Field Service Bulletin Trucks

Date Group No. Release Page 5.2018 **261 040 01** 1(2)

Expansion Tank, Installation VN, VHD, VAH

FSB 261-040, Expansion Tank, Installation

Expansion Tank Fastener Guide

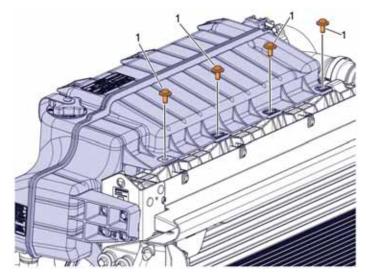
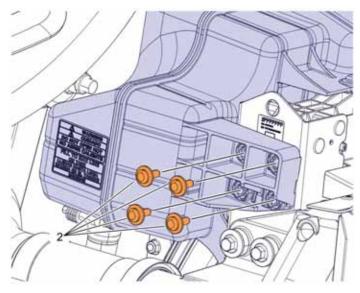
The expansion tank mounting fasteners must be installed in the same position they were removed from. Failure to install M8*20 mm, M8*25 mm, and M8*60 mm fasteners in the correct location could pierce the radiator and cause it to fail. Follow the fastener installation instructions outlined in this Field Service Bulletin (FSB).

Expansion Tank Fastener Guide			
Item	Description	Size	Qty
1	Flange Screw	M8* 20 mm	4
2	Flange Screw	M8* 25 mm	4
